INDIANA DEPARTMENT OF TRANSPORTATION

APPROVED MINUTES

May 21, 2015 Standards Committee Meeting

STANDARD SPECIFICATIONS, SPECIAL PROVISIONS AND STANDARD DRAWINGS
REVISION TO STANDARD DRAWINGS AND RECURRING PLAN DETAILS

801-TCSN-15 WOOD POST DESIGN FOR TEMPORARY PANEL SIGNS (WITH MARKUPS)

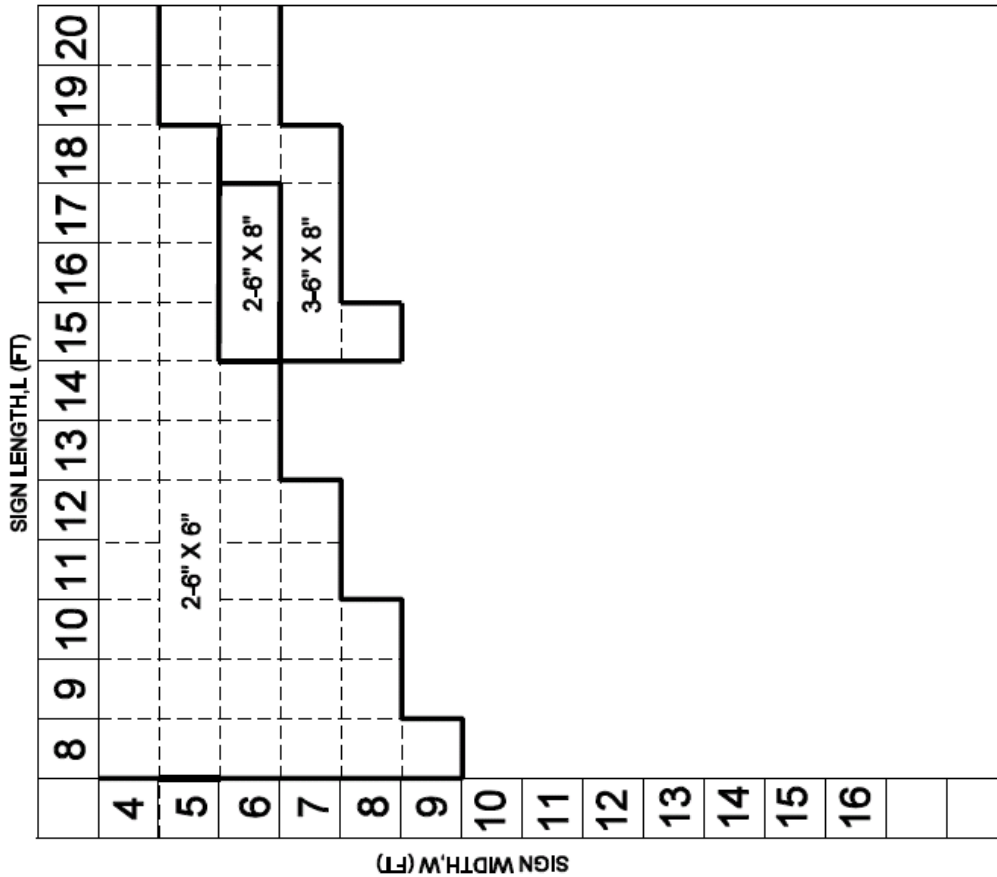
NOTES:
No more than one post can be located in a 7 foot wide path.

RECURRING PLAN DETAILS 801-R-542d WORKSITE ADDED PENALTY SIGN 78X42
(WITH MARKUPS)

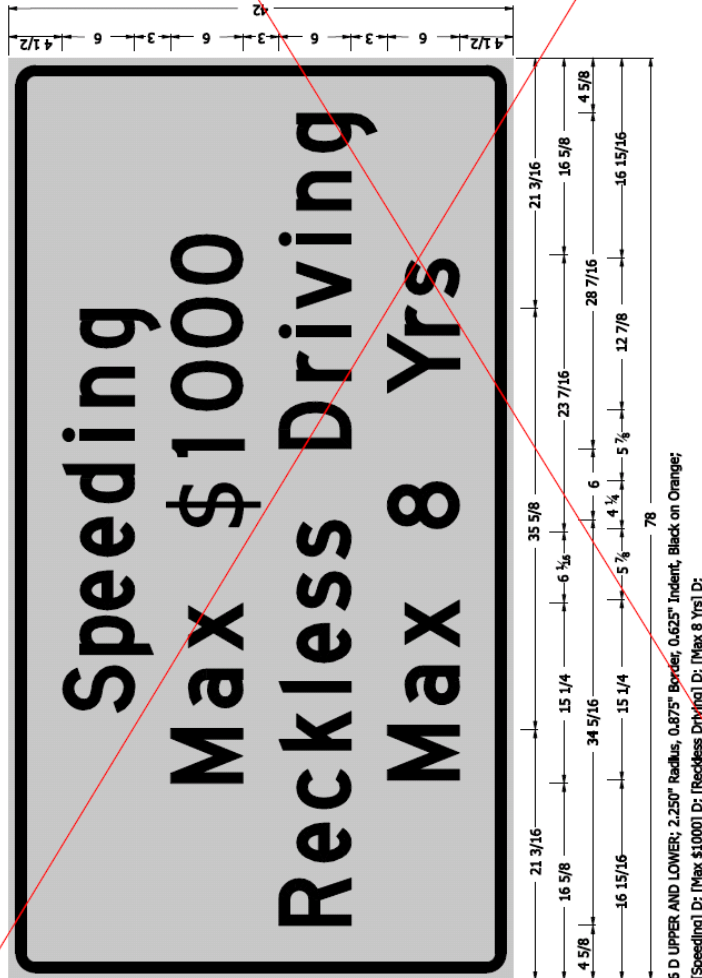
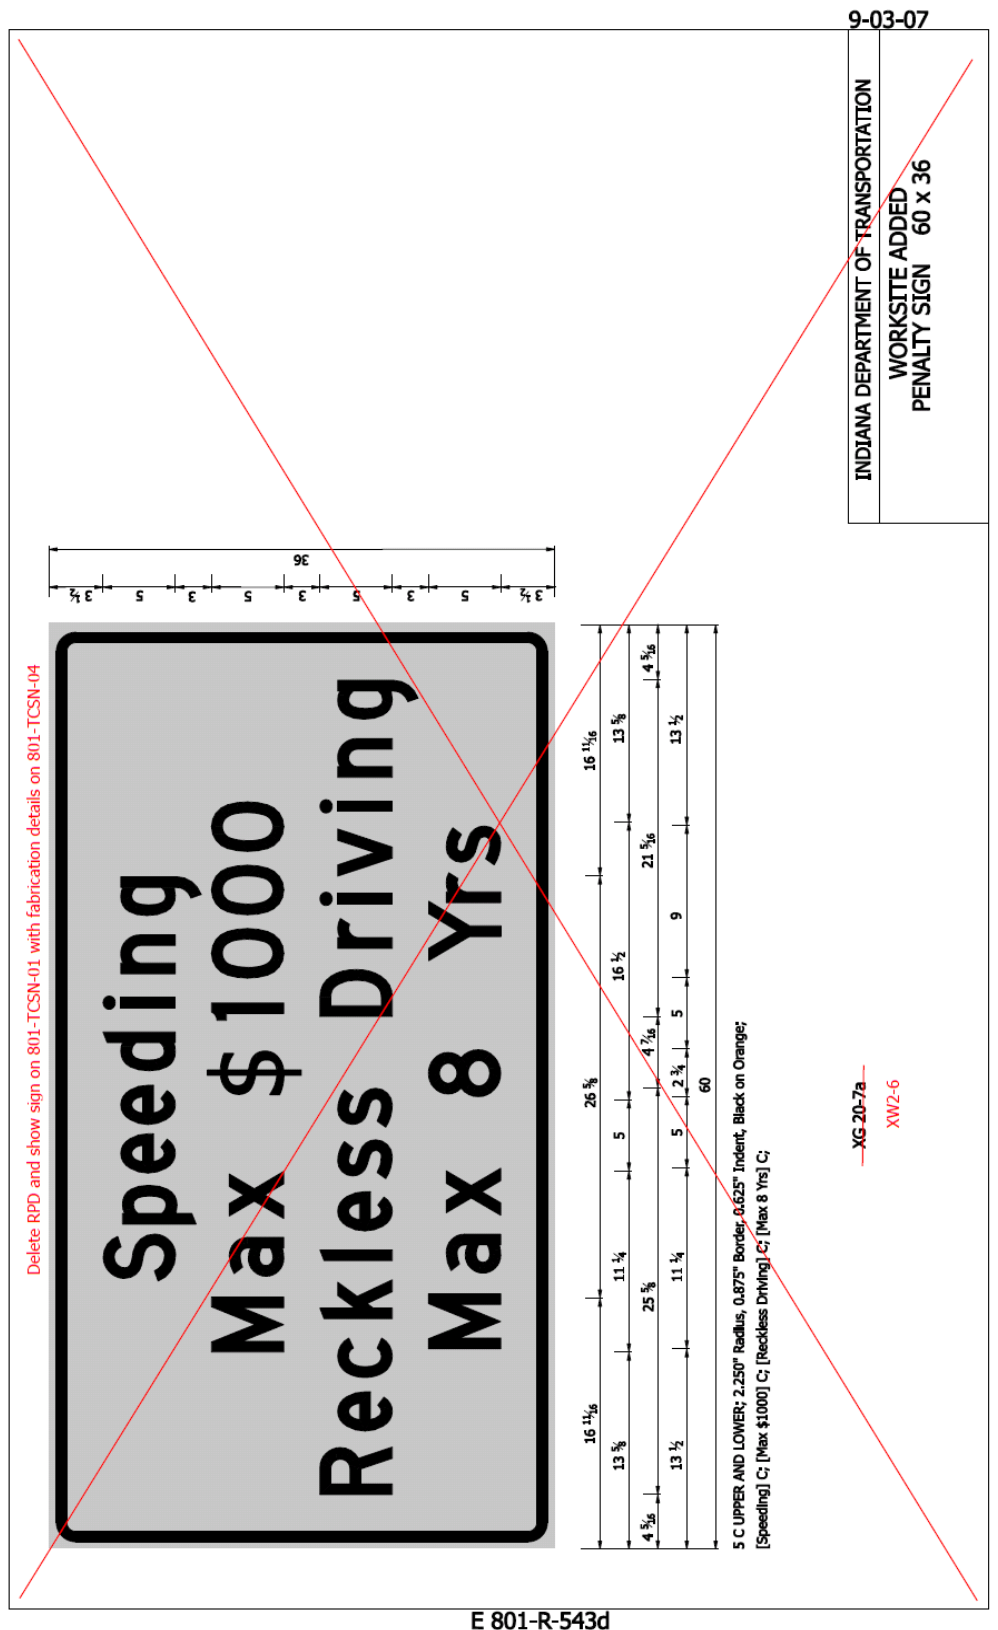
Delete RPD and show sign on 801-TCSN-01 with fabrication details on 801-TCSN-04
